This gallery shows some pictures of bad solderings - they should prevent you from making the same errors (feel free to add even more pictures here!)

Permanent link:
https://wiki.midibox.org/doku.php?id=bad_solderings_gallery

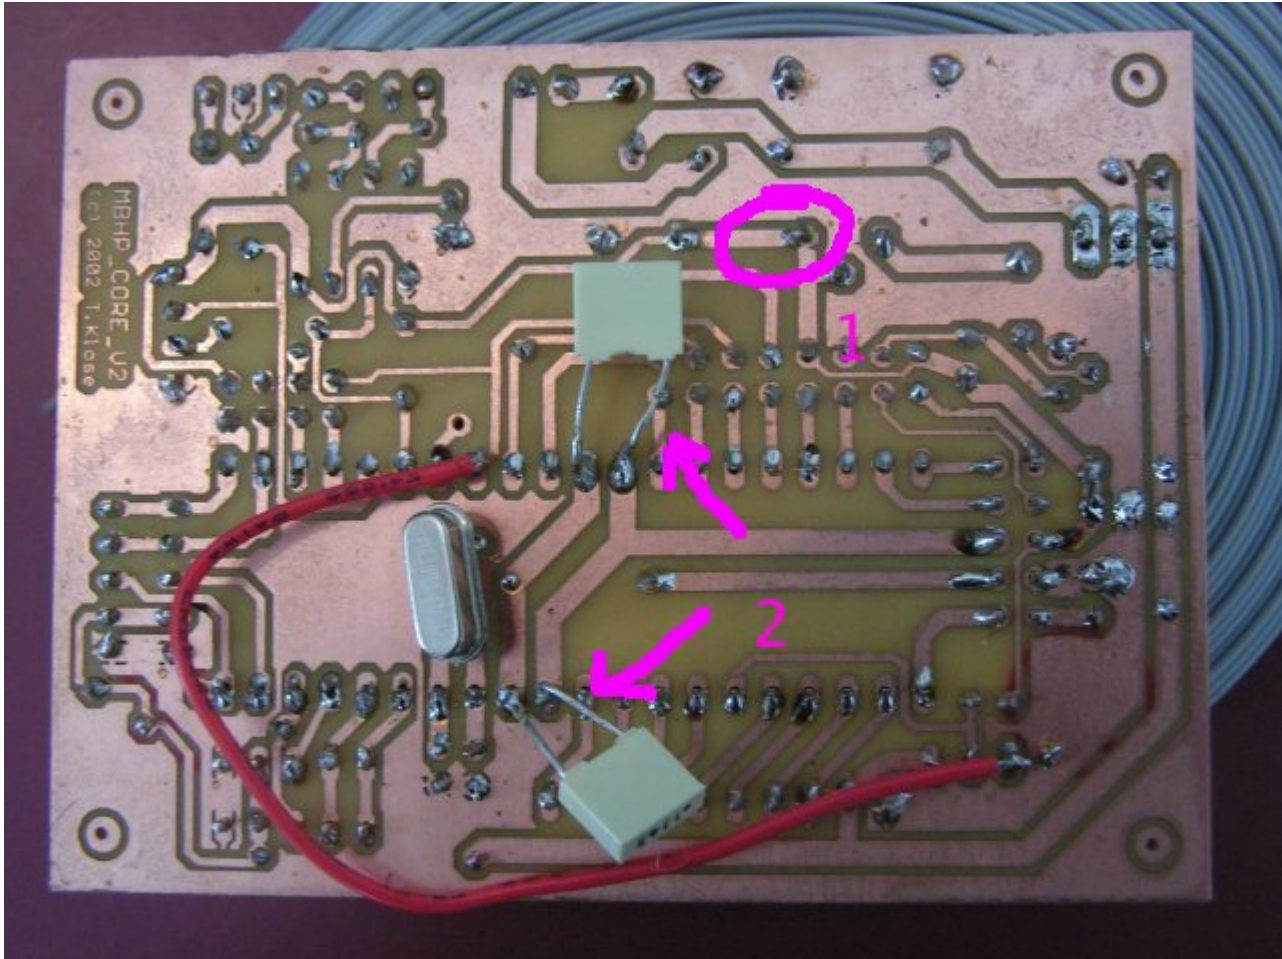
1: The core module has some badly soldered connections(loose), which could lead to failures. There are also missing solderings (e.g. 33pF cap below crystal). It makes sense to solder each pad again, the [Soldering](#) guide in the Wiki gives some useful tips

2: The legs of the caps should be cut, otherwise they can cause a short circuit which can damage the PIC!

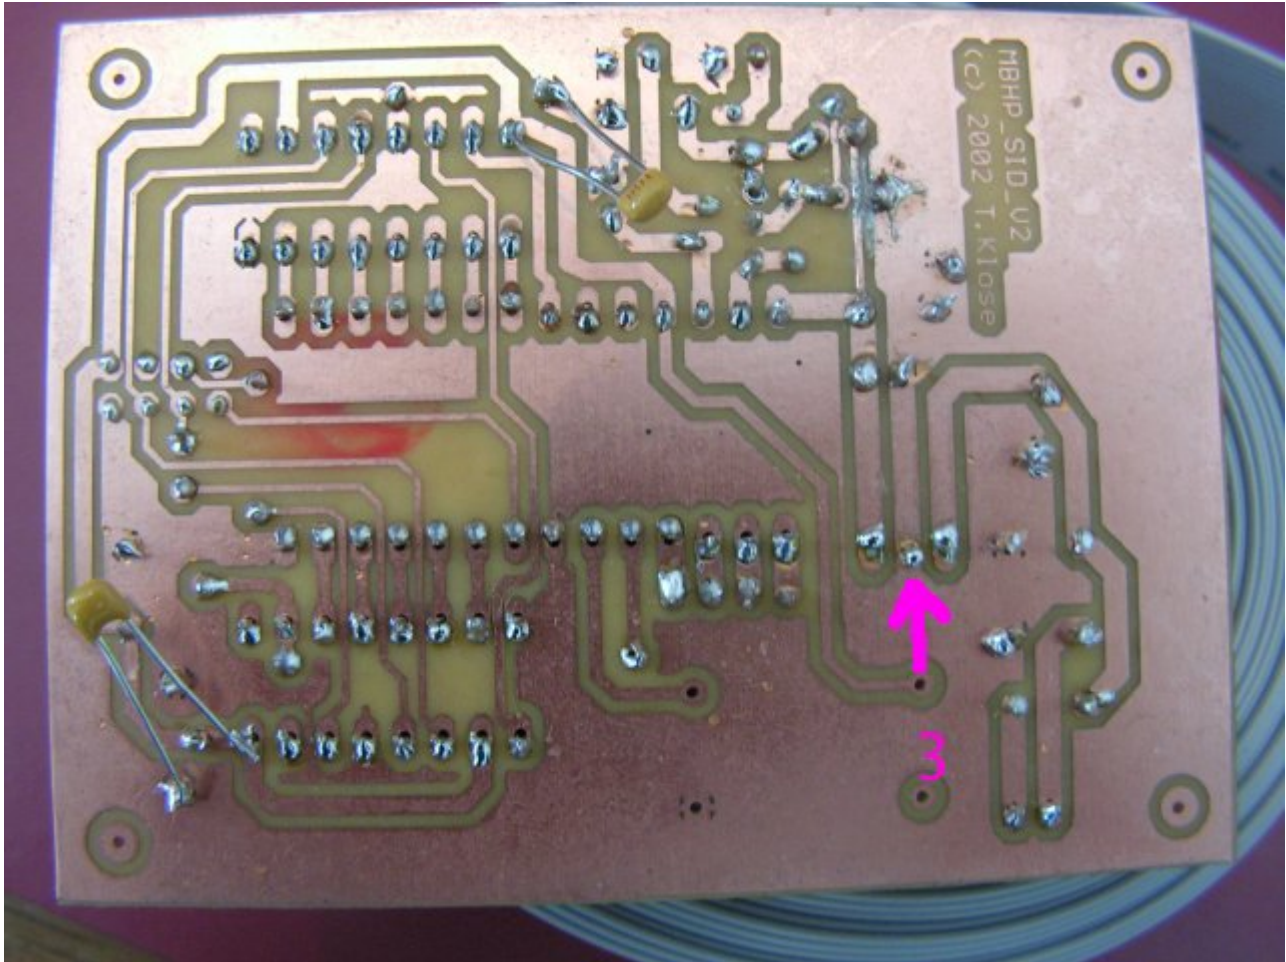
3: This seems to be a bad ground connection directly at the 78xx - it can lead to the wrong voltage. Here the same: just solder the pads again, it will help
And same as above: the long cap legs need to be cut, the danger of shorting out is too high!
